**HMC ARCHITECTS
3546 Concourses Street
Ontario, California 91764**

Arvin High School ESSER III Phase 1 Roofing

Kern High School District

File No: 15-H3 A#03-122508

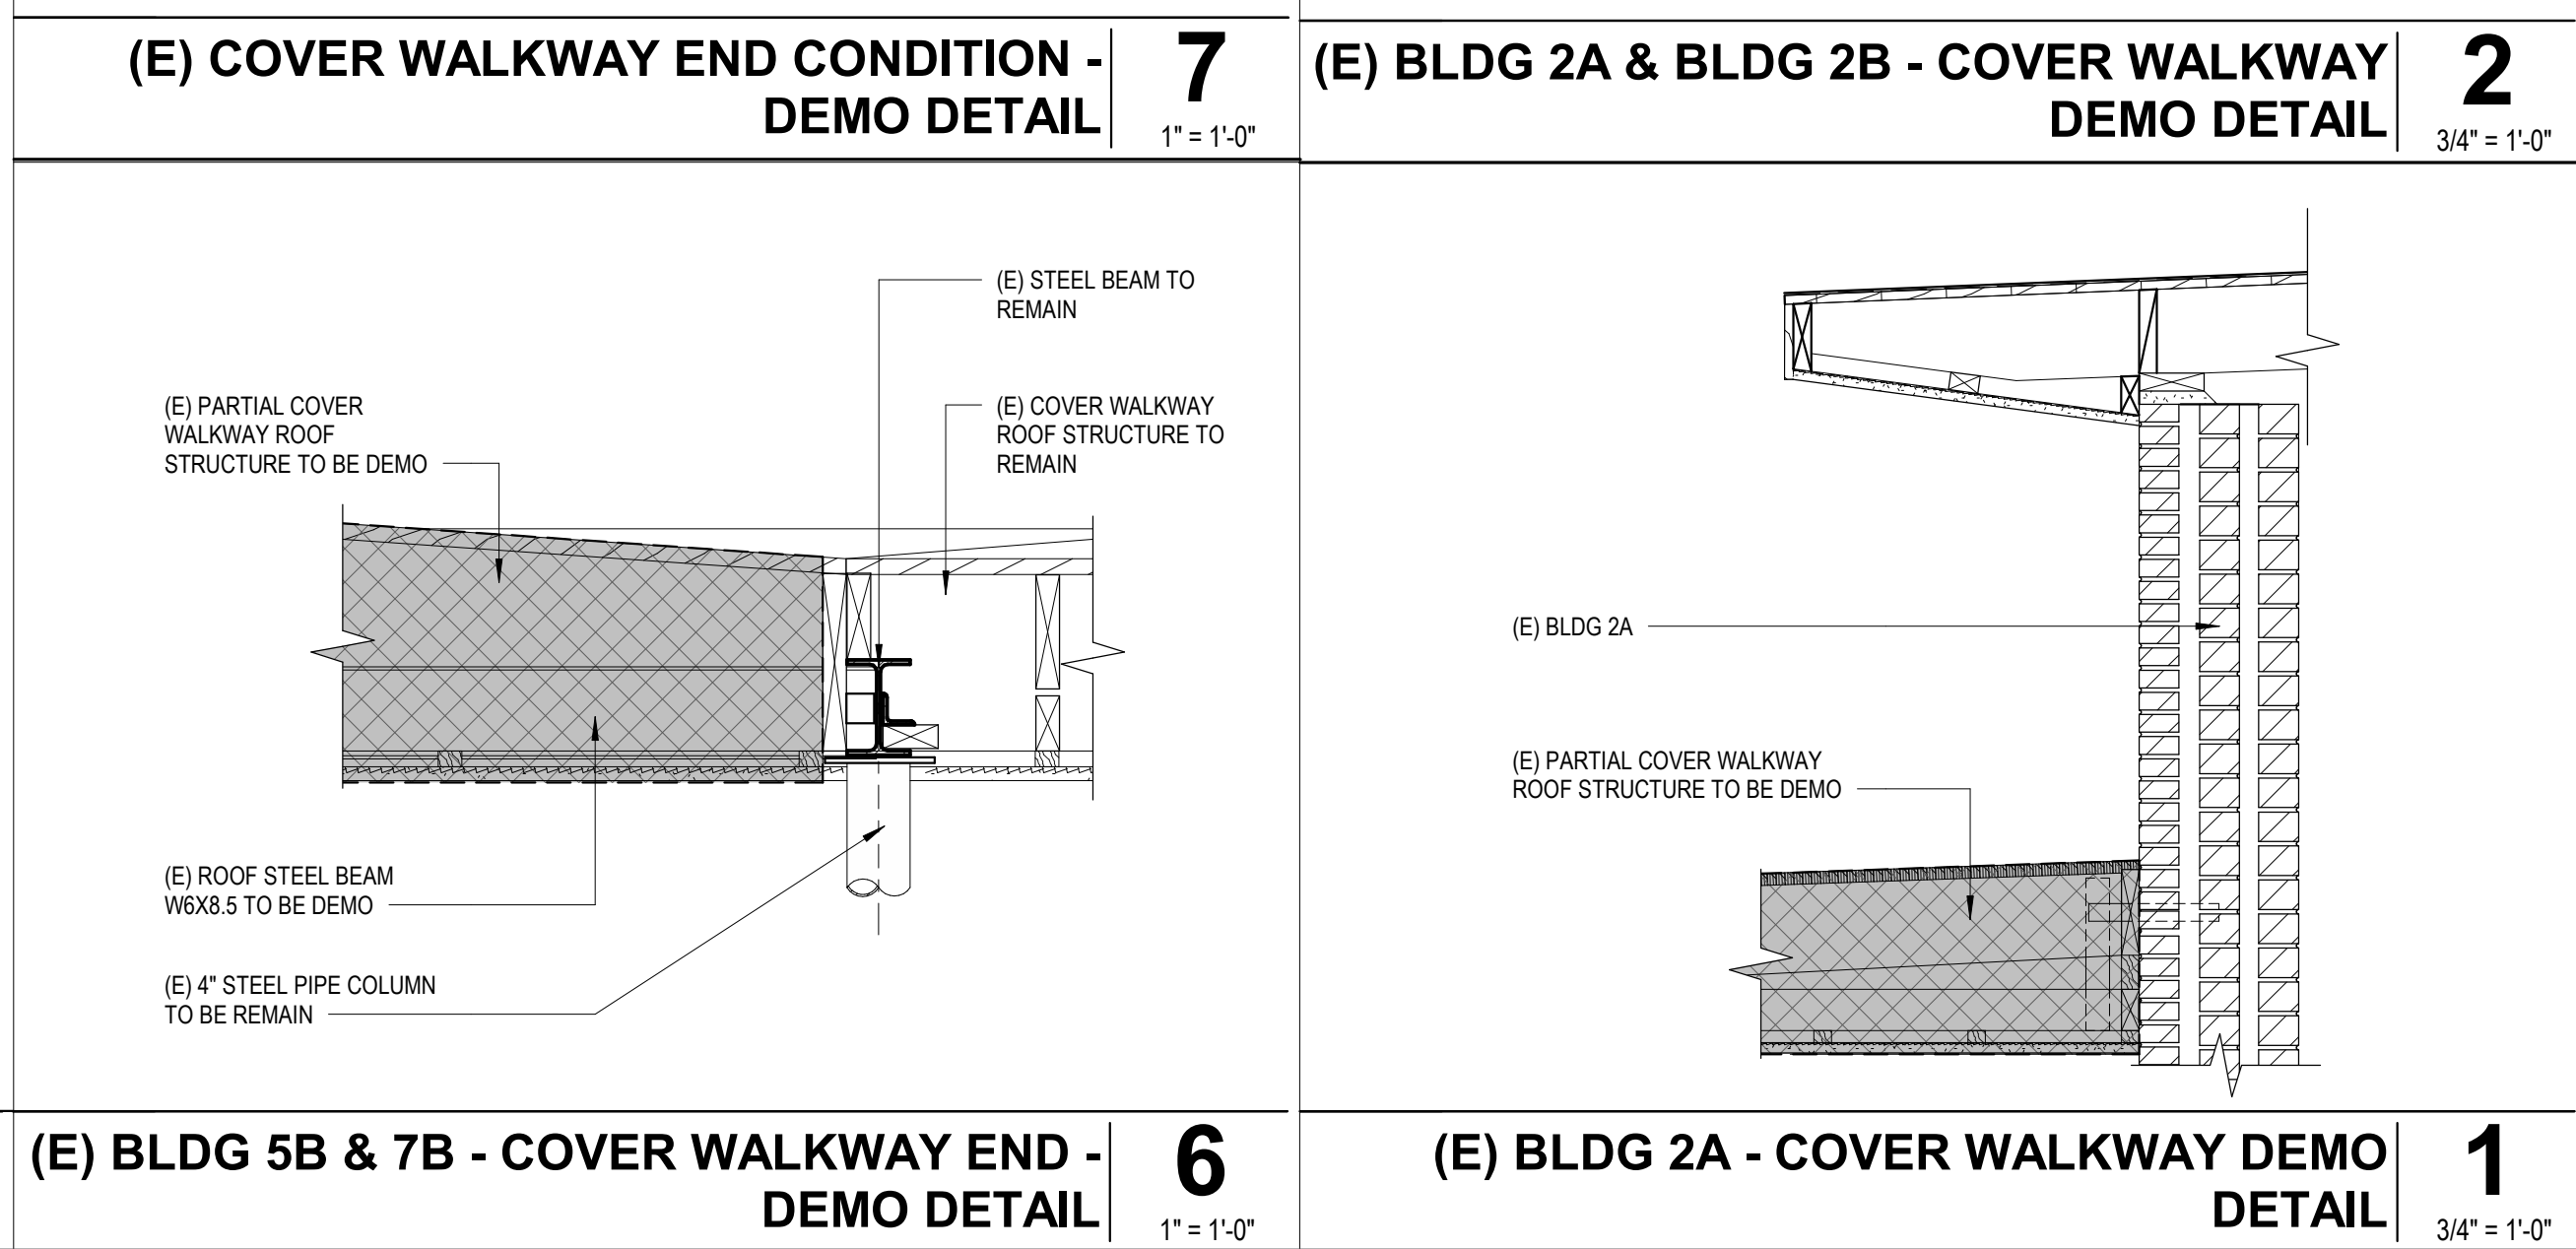
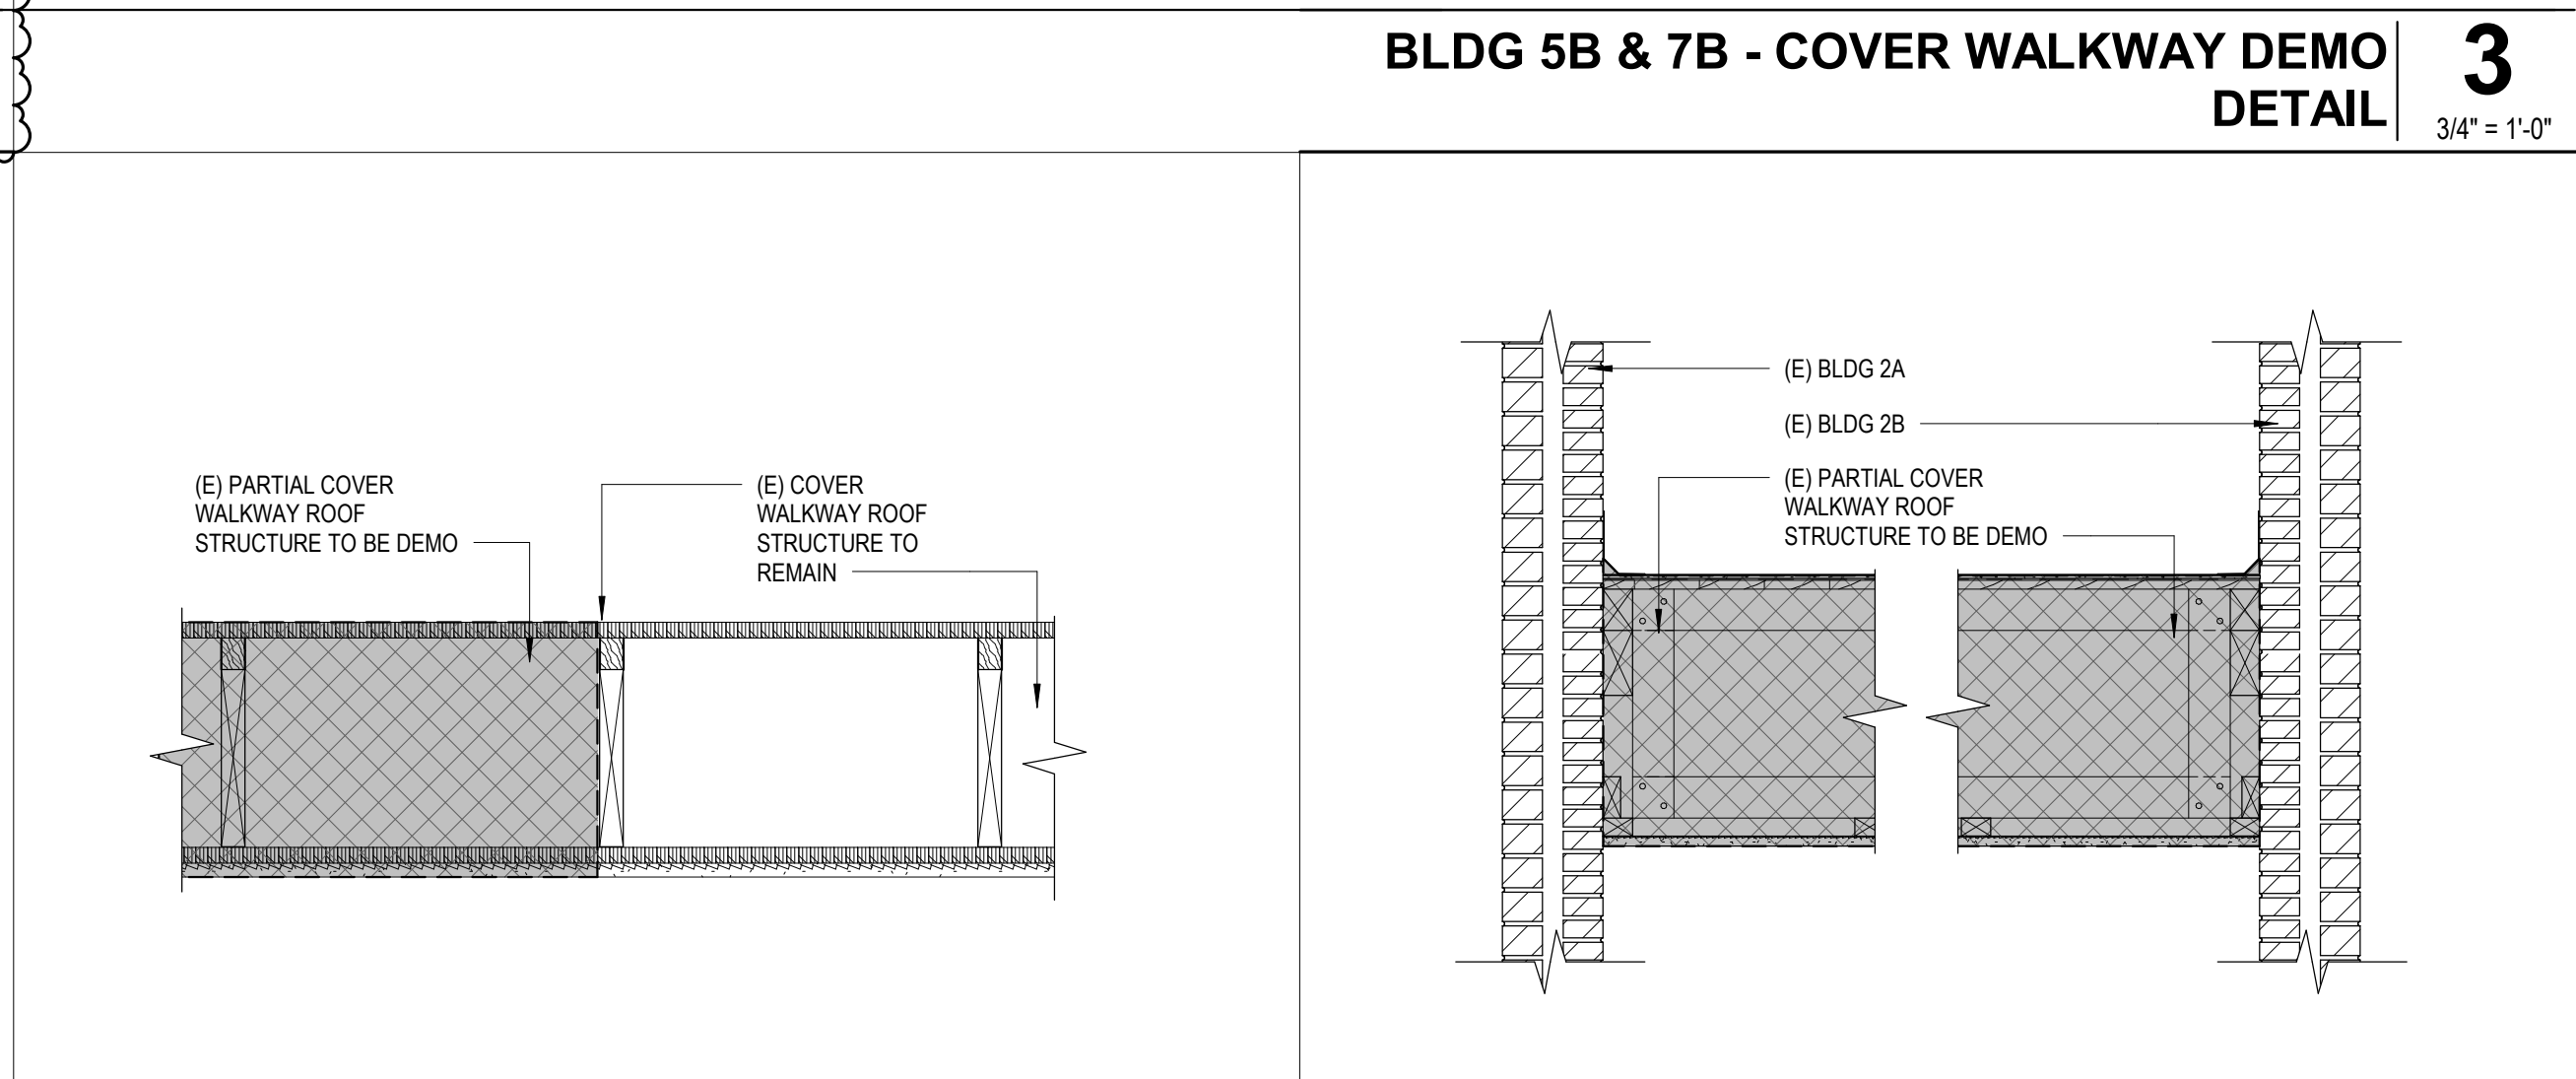
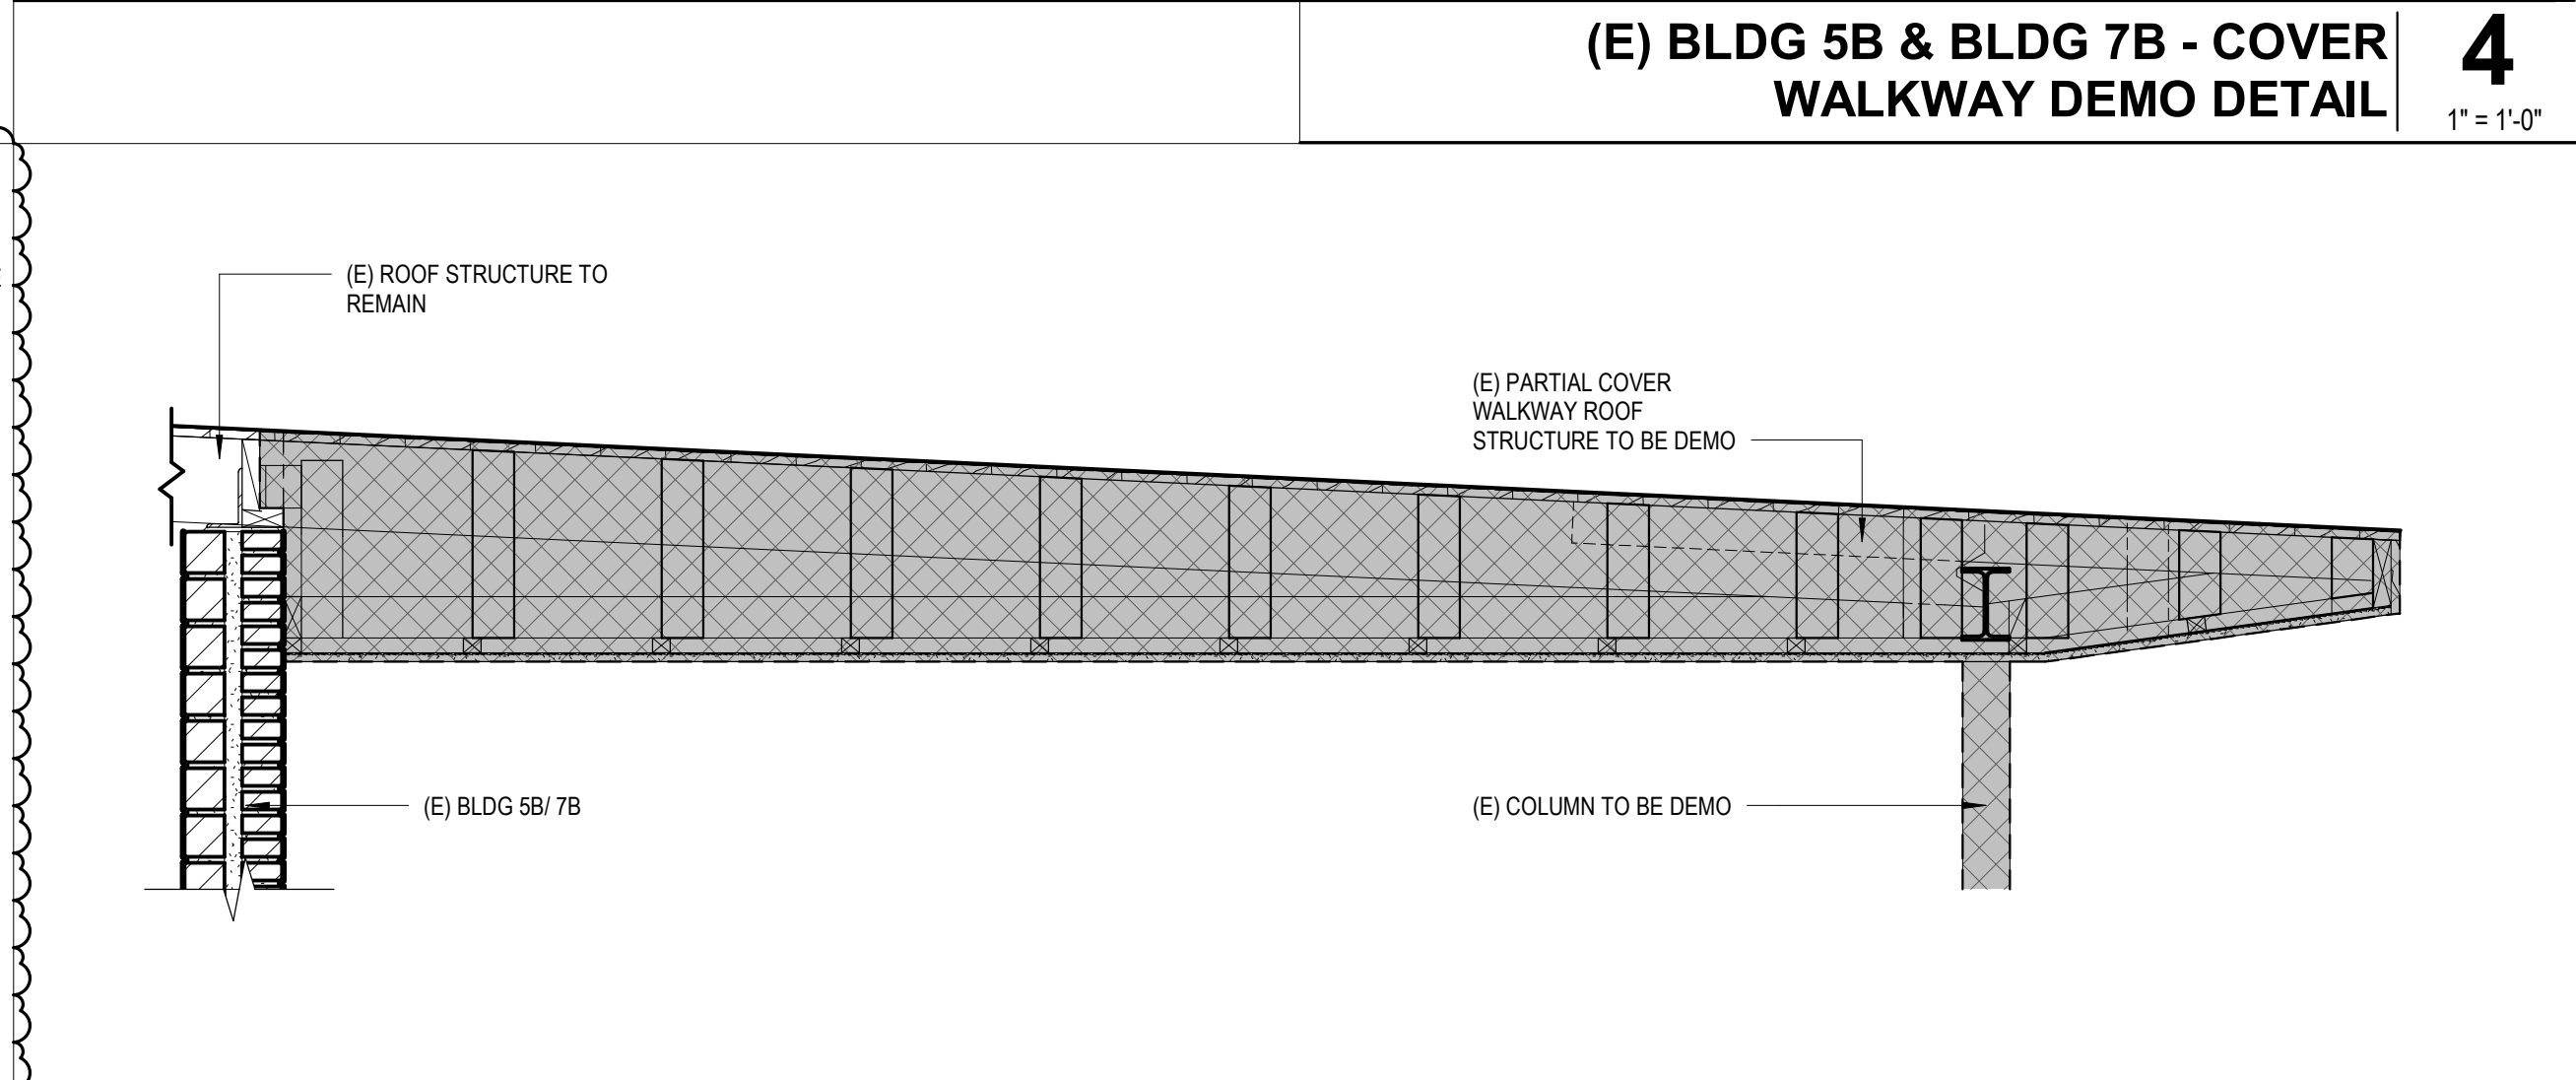
- A. **ADD** Details 8/A10.42 – Platform Edge and 12/10.42 – HVAC Mounting Detail to the Drawing Sheet as shown and clouded per Delta 3.
